Docket Number:	24-OPT-04
Project Title:	Potentia-Viridi Battery Energy Storage System
TN #:	263575
Document Title:	CEC Data Request #2 - Cumulative Impact Response
Description:	This document responds to the CEC's 5/19/2025 email regarding cumulative impacts related to the Project.
Filer:	Ronelle Candia
Organization:	Dudek
Submitter Role:	Applicant Consultant
Submission Date:	5/30/2025 2:09:01 PM
Docketed Date:	5/30/2025

CEC Data Request #2 – Cumulative
Impacts Response

Potentia-Viridi Battery Energy Storage Project

PV BESS-Mulqueeney Wind Figure

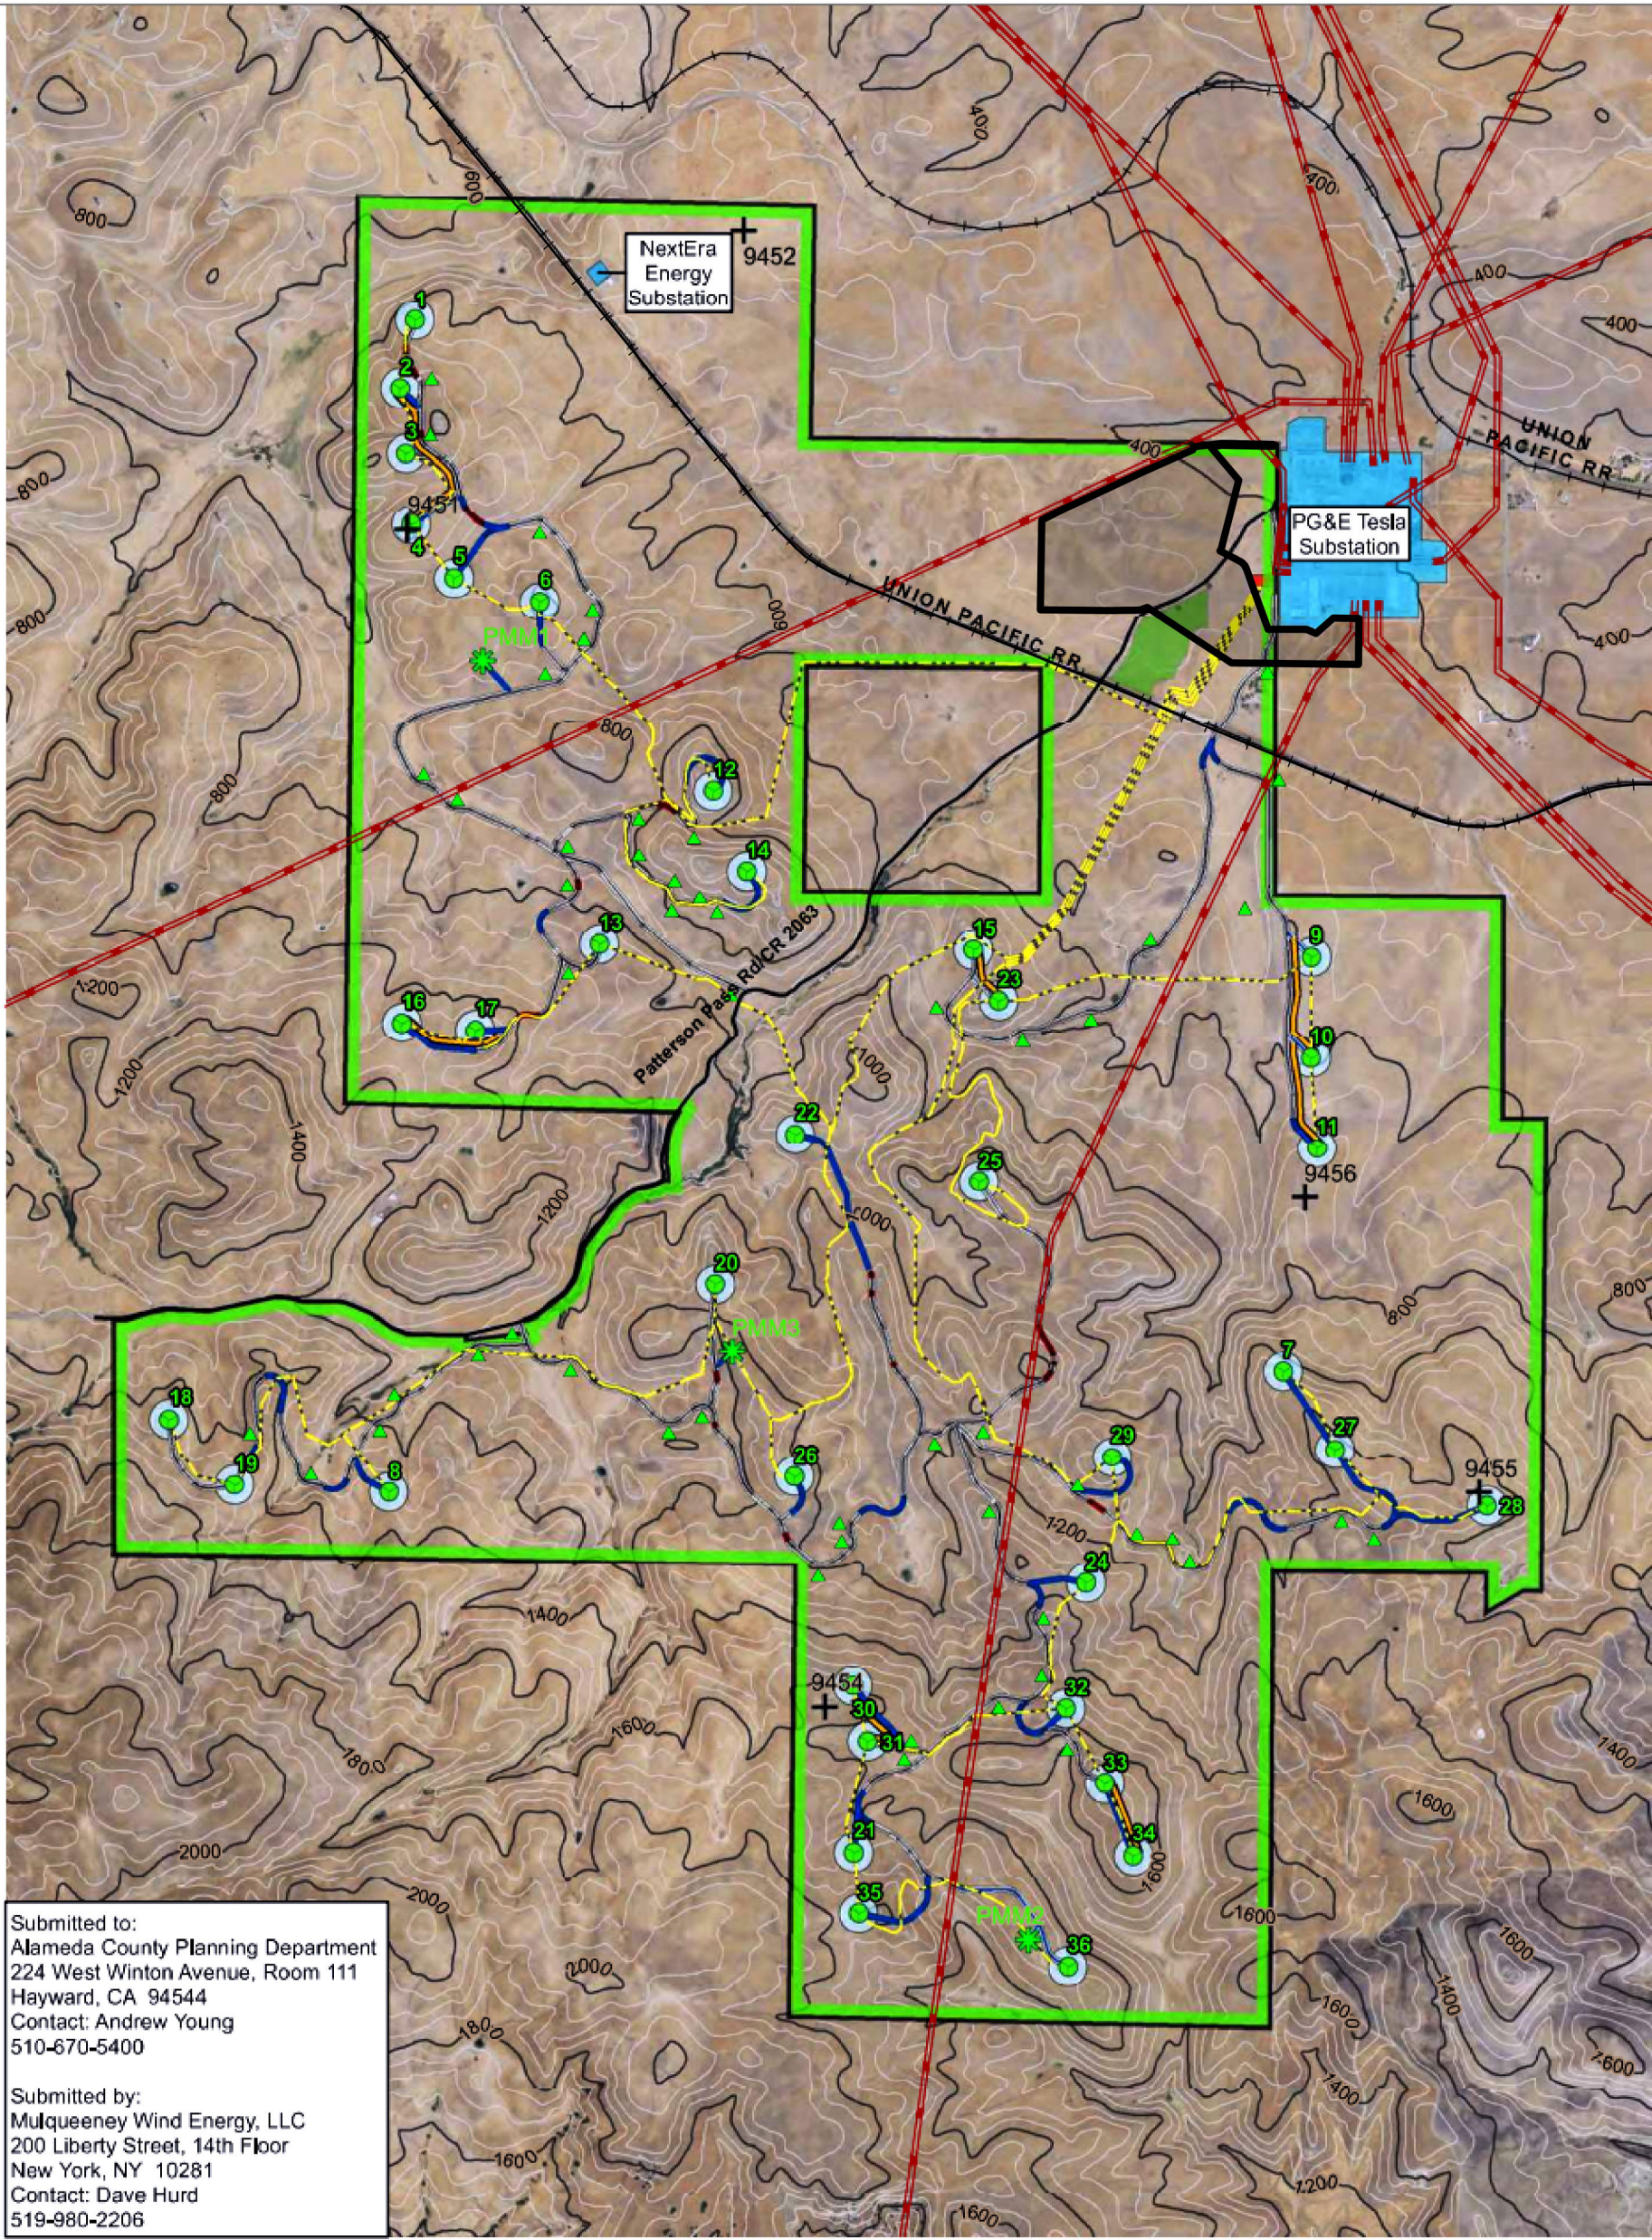
DR: *Explain why Potentia Viridi BESS is located within the footprint of the Mulqueeney Ranch Wind Repowering Project.*

Response: Mulqueeney Wind Energy, LLC (Mulqueeney Wind), a subsidiary of Brookfield Renewable (Brookfield), is developing the Mulqueeney Ranch Wind Repowering Project (Mulqueeney Ranch Wind Project) on privately owned parcels in the Altamont Pass Wind Resource Area (APWRA). The Mulqueeney Ranch Wind Project would entail the replacement of approximately 518 old generation wind turbines installed in the 1980s with up to 36 new wind turbines.

The Mulqueeney Ranch Wind Project footprint, as shown in the Mulqueeney Ranch Wind Repowering Project Final Subsequent EIR (State Clearing House # 2010082063), comprises 29 parcels extending over 4,600 acres. Ground disturbing activities would occur on a small portion of the overall Mulqueeney Ranch Wind Project area. The Potentia-Viridi BESS Project boundary is located at what was identified as the north-east corner of the Mulqueeney Ranch Wind Project footprint in the EIR (see attached PV BESS-Mulqueeney Wind figure). The Potentia-Viridi BESS Project has secured real estate rights for the Project footprint and have confirmed there are no conflicts in real estate interests. The Mulqueeney Ranch Wind Project will develop a temporary construction staging area, a underground collector line, project substation, and 300' overhead transmission line connecting the substations in the same area the Potentia-Viridi BESS Project gen-tie line is proposed, in the area east of Patterson Pass Road. Wind turbine installation is not proposed within or near the construction staging area. A crossing agreement has been executed between Levy Alameda, LLC and Brookfield to allow both projects interconnection to the Tesla Substation as already approved by PG&E and CAISO.
